Site Instruction

SI 21

PROJECT : Hampton Manor
PROJECT No : 1136.13
DATE : June 21, 2018

Title: Revised Generator Layout

WEST ELEVATION 1
SCALE - 1/8" = 1'-0" A401a

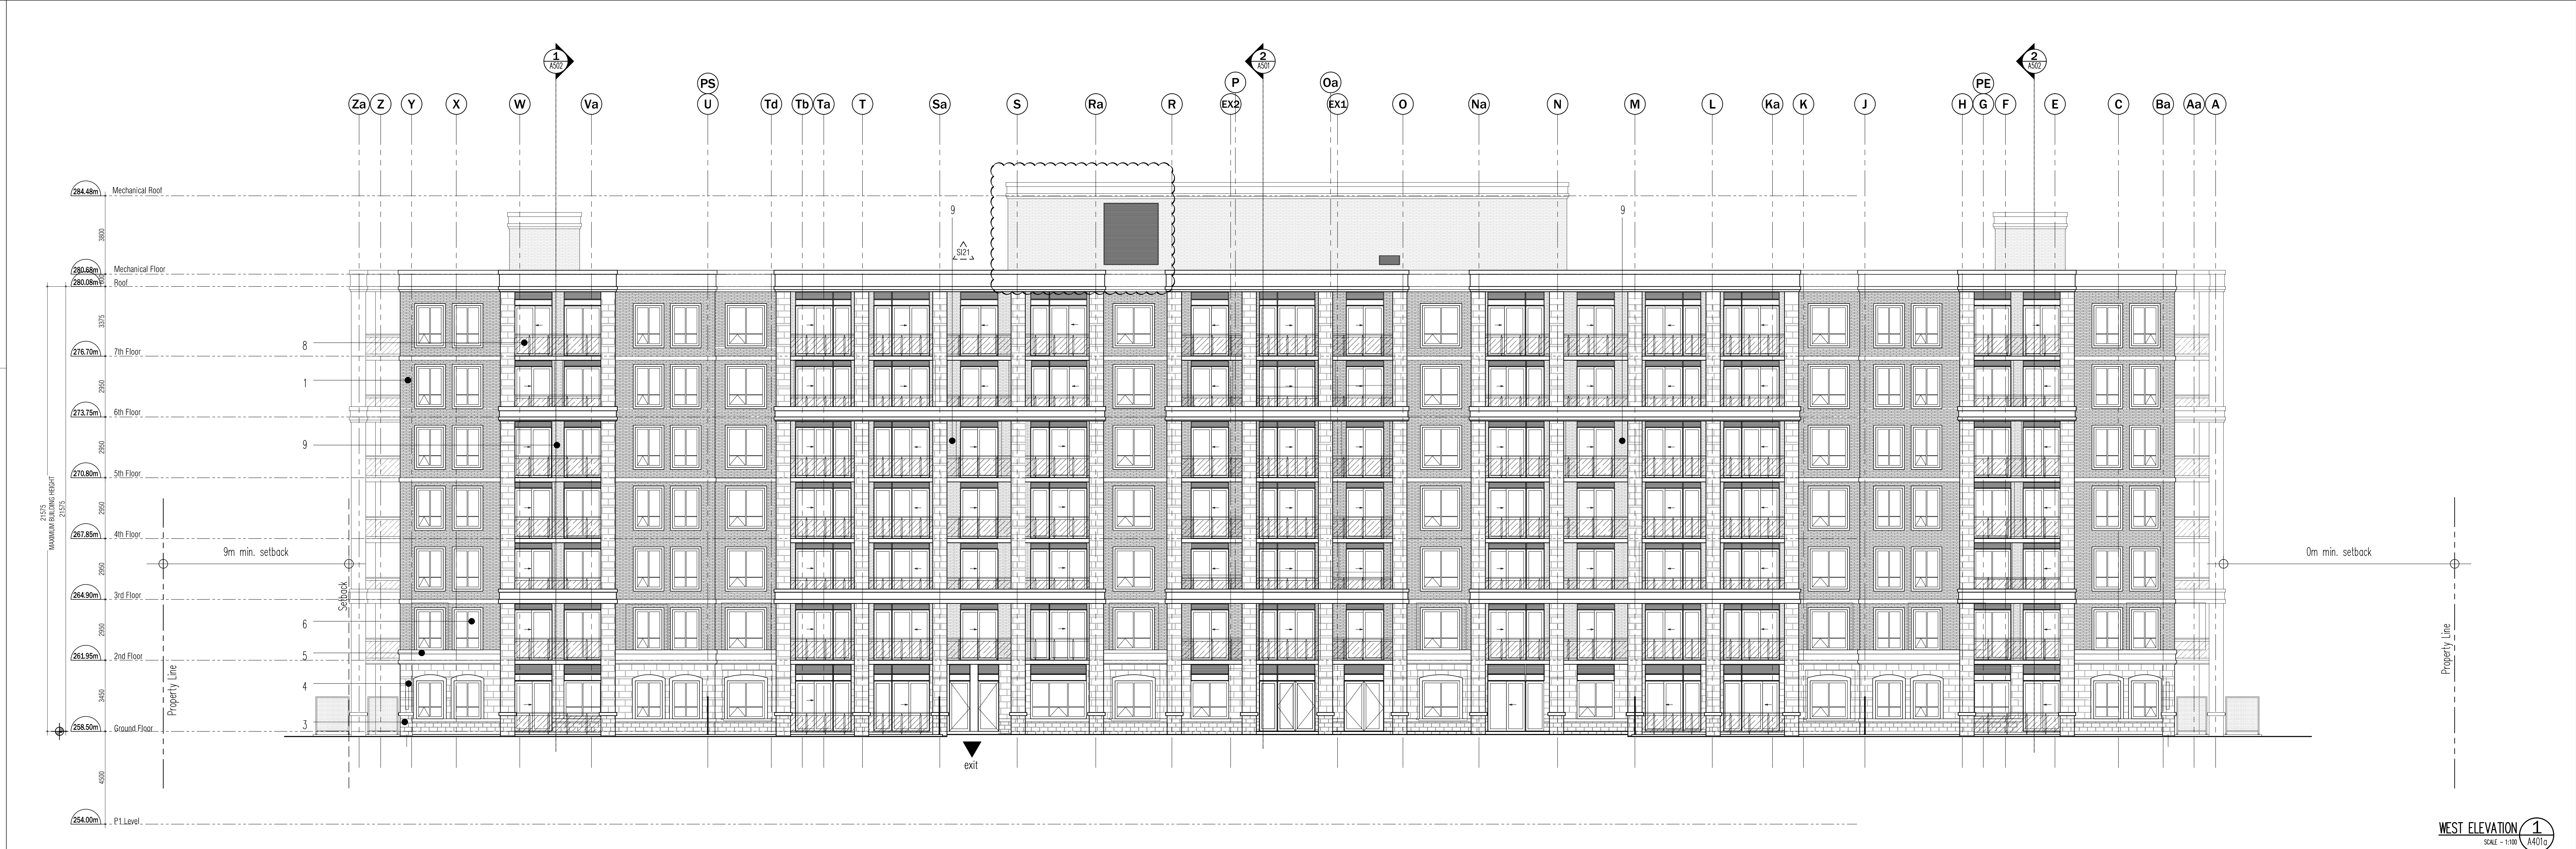
A401a & A401b – Elevations

- Revised generator room layout showing exhaust louver relocation.

Building Section

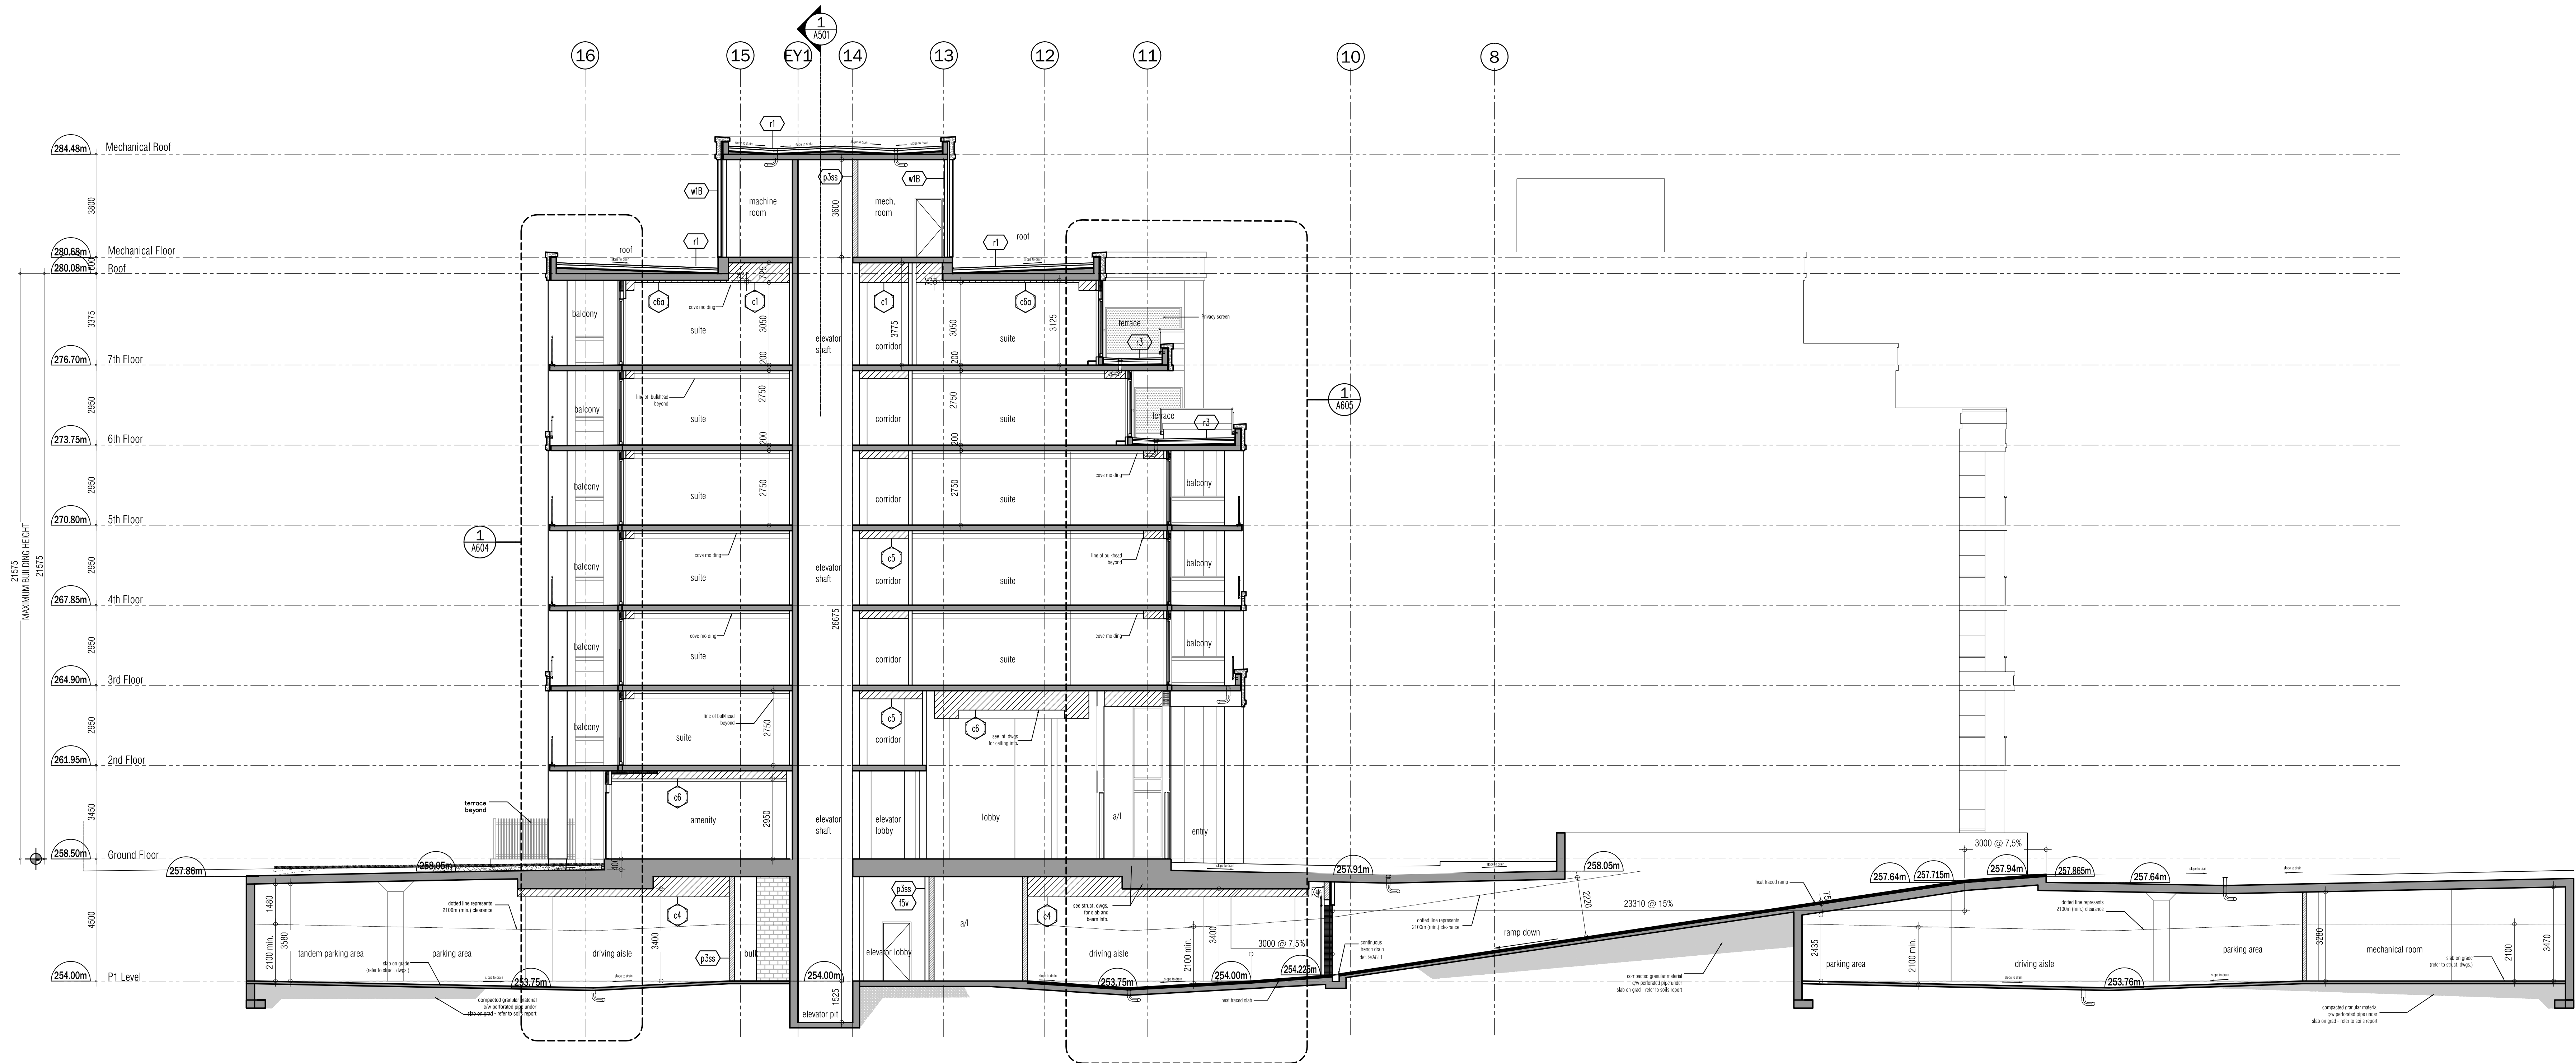
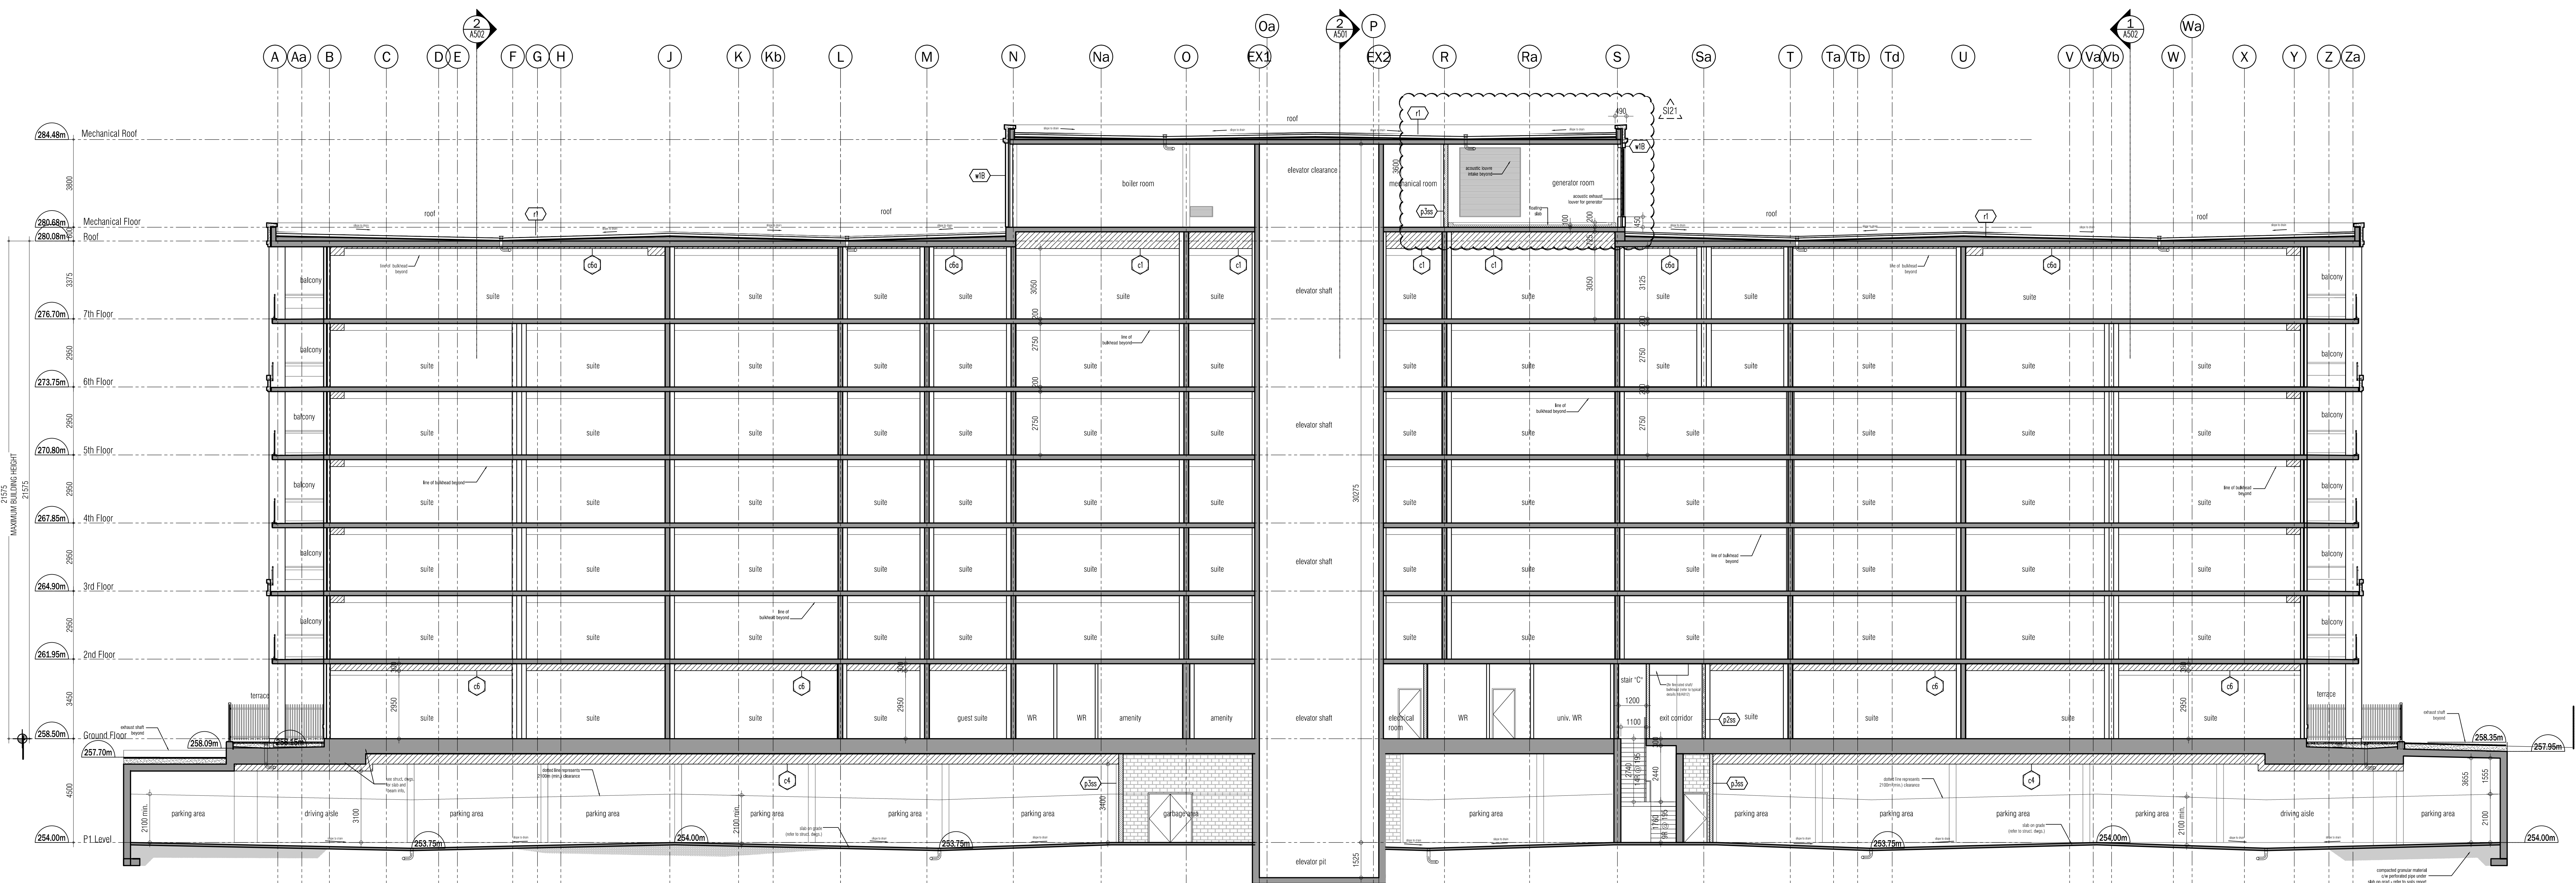
A501 – Building Section

- Revised generator room layout showing exhaust louver relocation.
